## ADDENDUM NO. 1, September 30, 2020 *(Revised October 1, 2020)*

RE: POK-DIP 151C  
Project No. 2190380.01

FROM: **Mackenzie**  
The Hudson Building  
101 E 6<sup>th</sup> Street, #200  
Vancouver, WA 98660  
(360) 695-7879

1 SITE PLAN  
C1.11

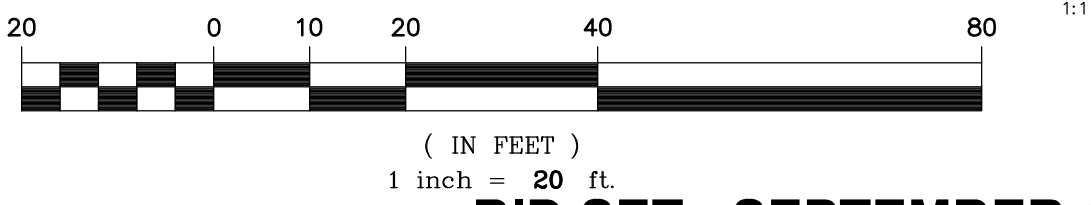
5. Are gas and fiber required and where are they located?
  - A. Yes, they are required and would be provided and coordinated with utility company's by GC. See revised drawings for gas meter location.

| CIVIL DOCUMENT CHANGE LOG                                                                  |                |               |               |                               |              | Mackenzie<br>1515 SE Water Ave, Ste 100, Portland OR 97214 (503) 224-9560                                                                                                                                                                                                                                                                               |
|--------------------------------------------------------------------------------------------|----------------|---------------|---------------|-------------------------------|--------------|---------------------------------------------------------------------------------------------------------------------------------------------------------------------------------------------------------------------------------------------------------------------------------------------------------------------------------------------------------|
| C1.11                                                                                      | ADDENDUM #1    | A             | 9/30/2020     | 1                             | 1,2,3        | ADJUSTED METER LOCATIONS AND ADDED GAS METER LOCATION.                                                                                                                                                                                                                                                                                                  |

1  
L1.10

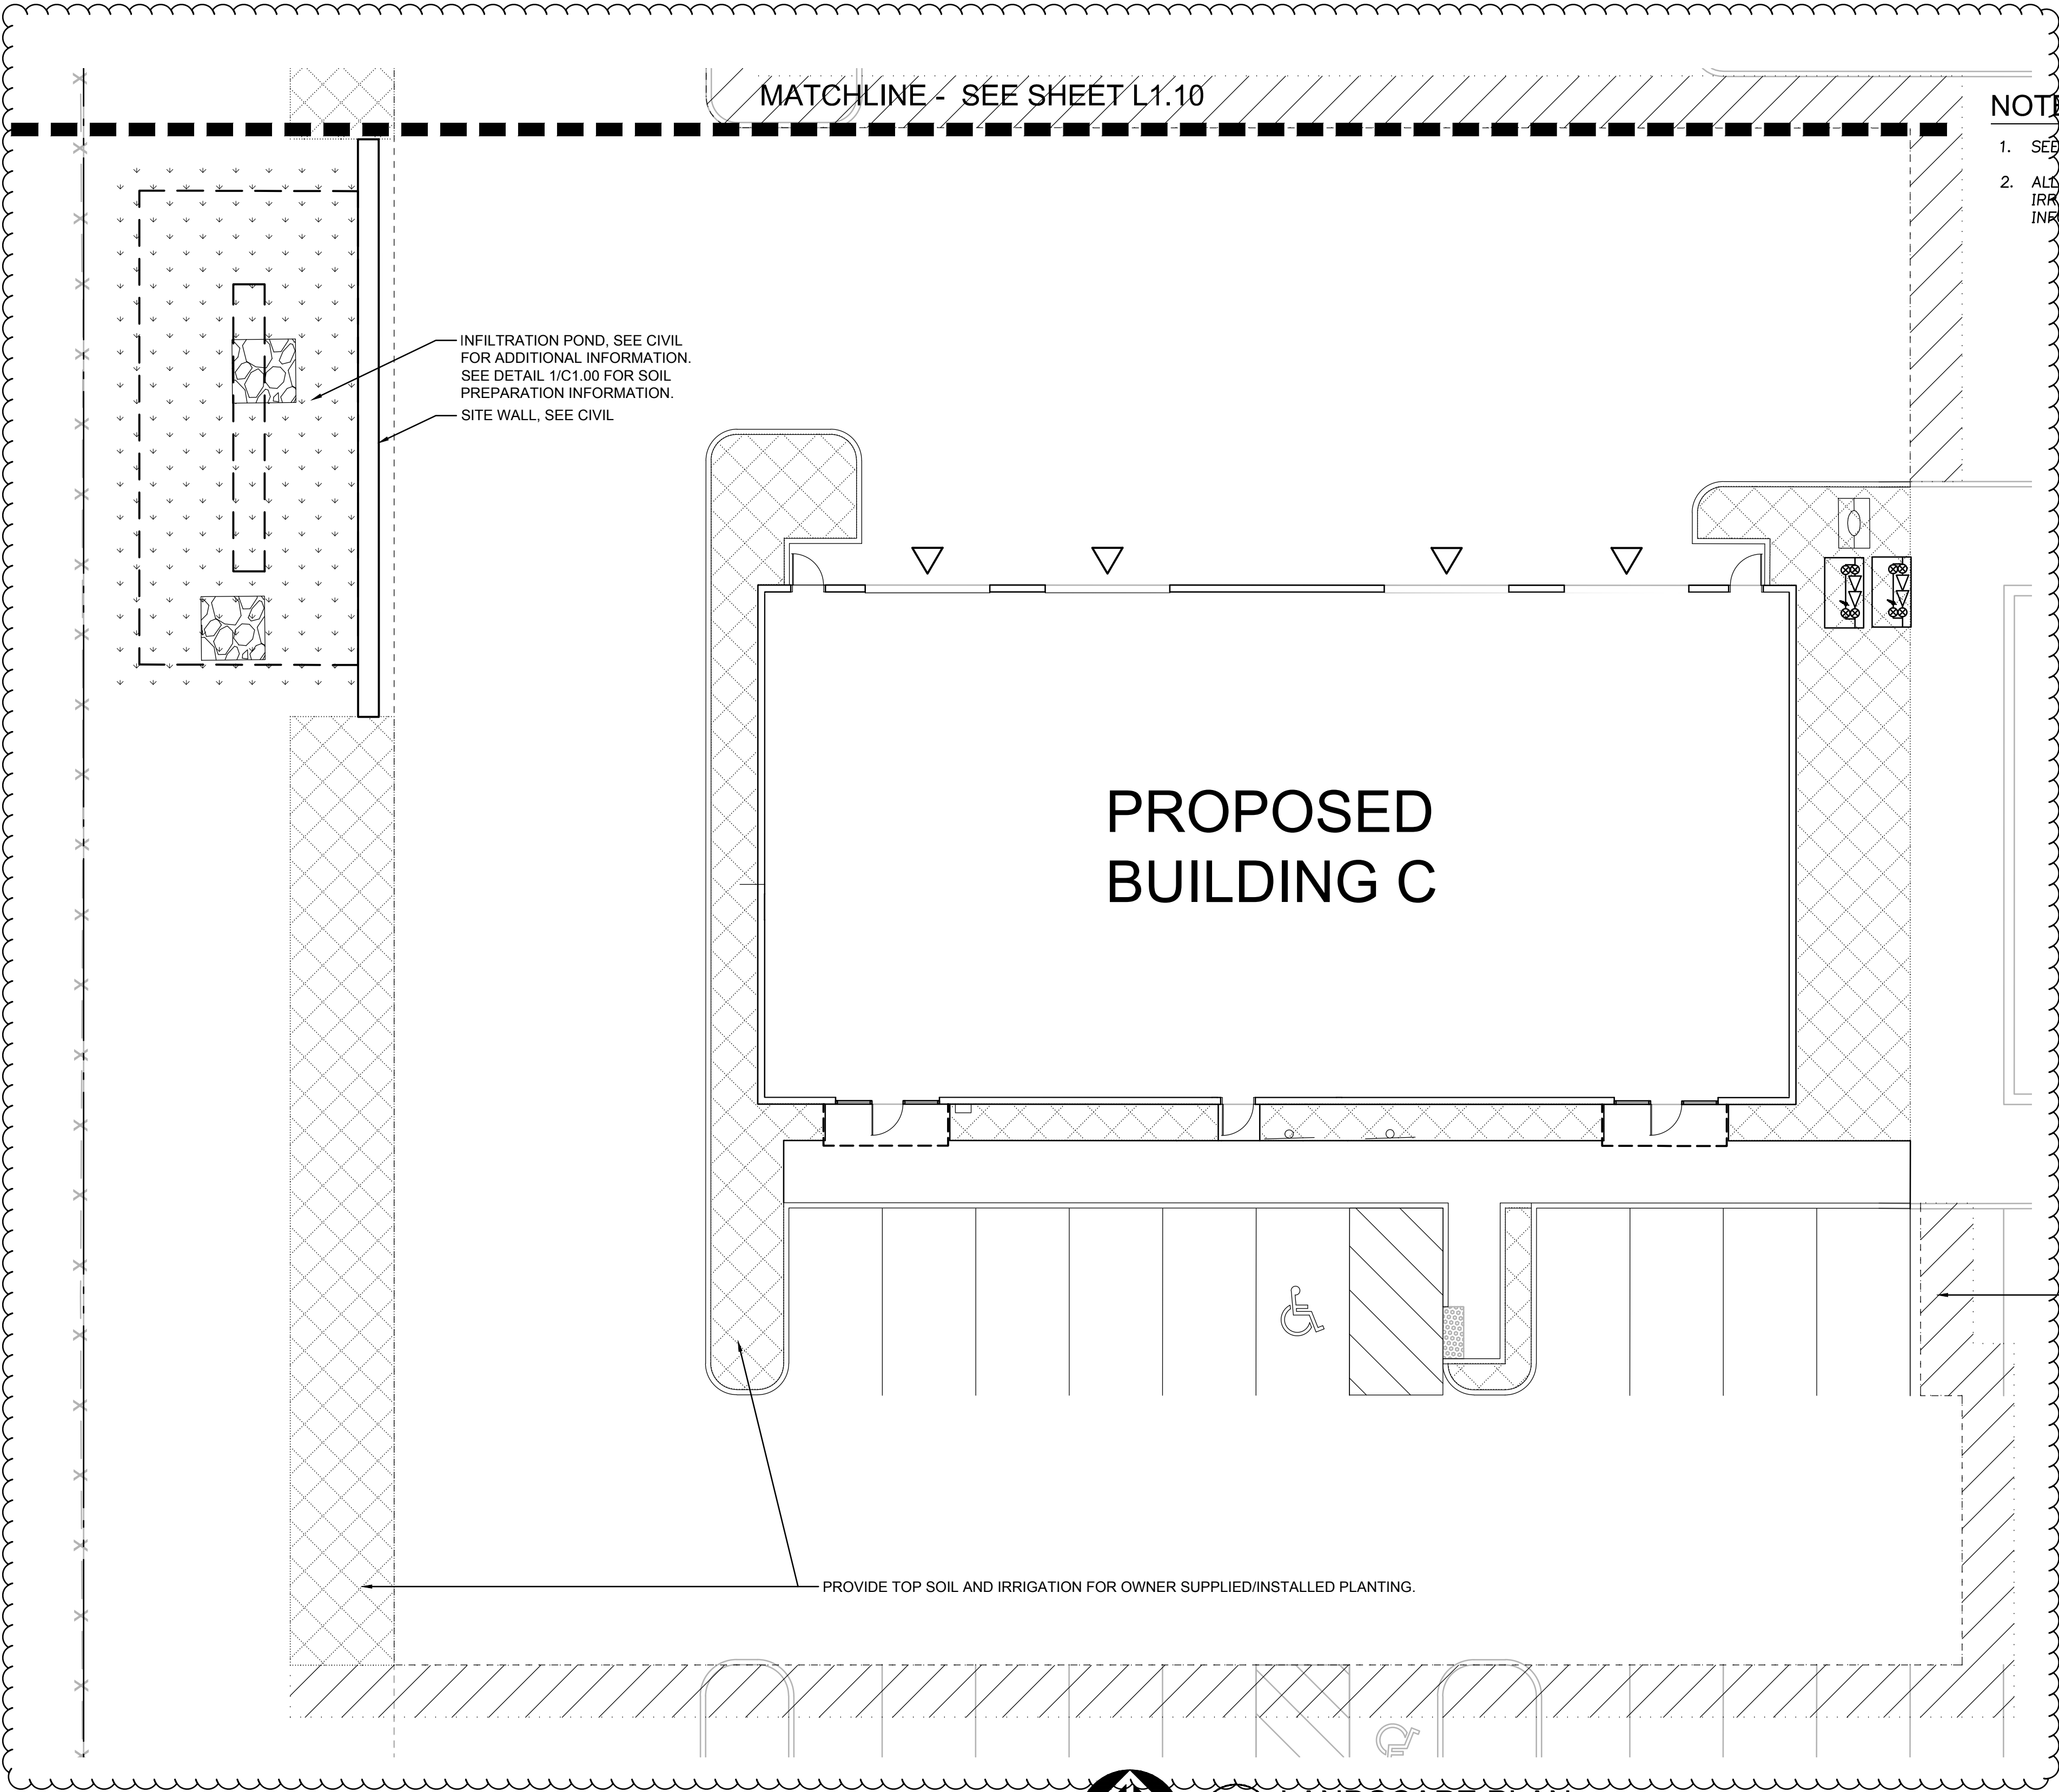
58. We understand topsoil for planting area is by GC, plant and placement is by owner. Please confirm Bio Swale plants and placement is by GC? Please confirm if irrigation system is by GC?

| LANDSCAPE DOCUMENT CHANGE LOG                                                              |                |               |               |                               |              | Mackenzie<br>1515 SE Water Ave, Ste 100, Portland OR 97214 (503) 224-9560                                                                                                                                                                                                                                                                               |
|--------------------------------------------------------------------------------------------|----------------|---------------|---------------|-------------------------------|--------------|---------------------------------------------------------------------------------------------------------------------------------------------------------------------------------------------------------------------------------------------------------------------------------------------------------------------------------------------------------|
| L1.10                                                                                      | ADDENDUM #1    | A             | 9/30/2020     | 3                             | 1,2,3        | ADDED HATCH AREAS FOR DISTURBED AREA WITH NOTE FOR SEED MIX TO BE PROVIDED. ADDED HATCH AREA FOR PLANTING AREA TO GET TOPSOIL AND IRRIGATION PROVIDED BY GC.                                                                                                                                                                                            |

- A. Confirmed, bioswale planting by GC, see revised landscape sheets. Confirmed irrigation system design build by GC.
59. Sheet A6.10 plumbing note C references underground sewer/plumbing for four future single occupant toilet rooms. 1/A1.10 keynote 12 shows one location. Please confirm you want 4 future and clarify locations.

11  
S0.22  
TYPICAL FULL HEIGHT PARTITION WALL  
3/4" = 1'-0"

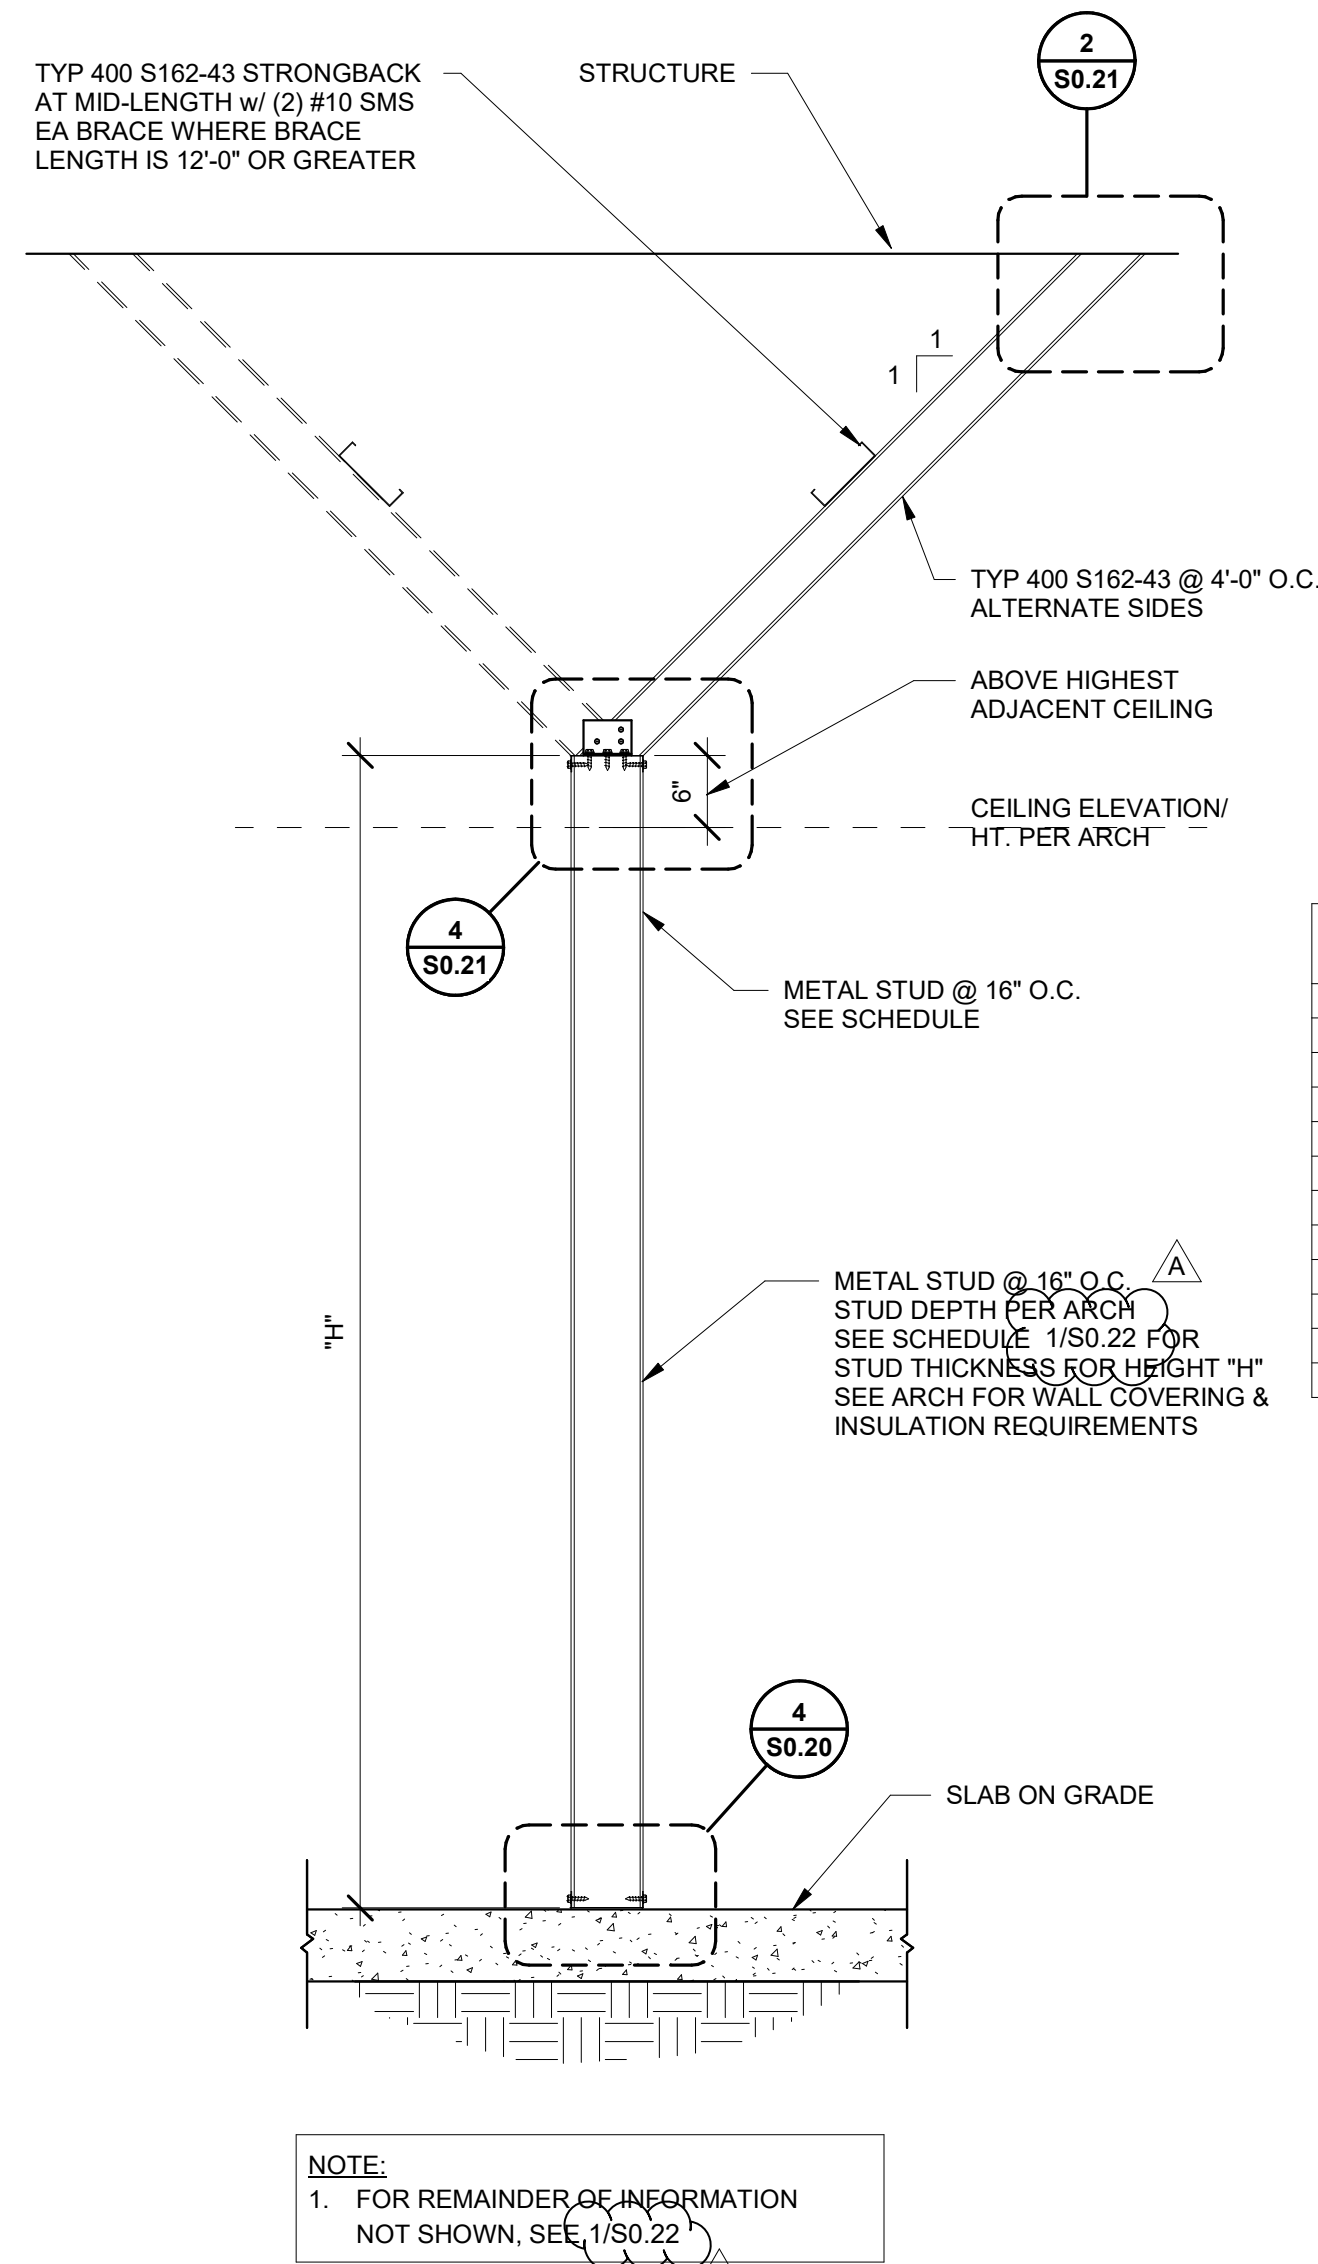
34. Drawing S0.22 detail 11 & 12. Both have a note to reference detail 17/S.20. - This detail does not exist on drawing S0.20, please verify.
- A. Detail reference 17/S0.20 should be updated to 1/S0.22.

| STRUCTURAL DOCUMENT CHANGE LOG                                                             |                |               |               |                               |              | Mackenzie<br>1515 SE Water Ave, Ste 100, Portland OR 97214      (503) 224-9560                                                                                                                                                                                                                                                                          |
|--------------------------------------------------------------------------------------------|----------------|---------------|---------------|-------------------------------|--------------|---------------------------------------------------------------------------------------------------------------------------------------------------------------------------------------------------------------------------------------------------------------------------------------------------------------------------------------------------------|
| S0.22                                                                                      | ADDENDUM #1    | A             | 9/30/2020     | 3                             | 1,2,3        | adjusted detail callout within details 11&12 to reference 1/S0.22 in lieu of 17/S0.20                                                                                                                                                                                                                                                                   |
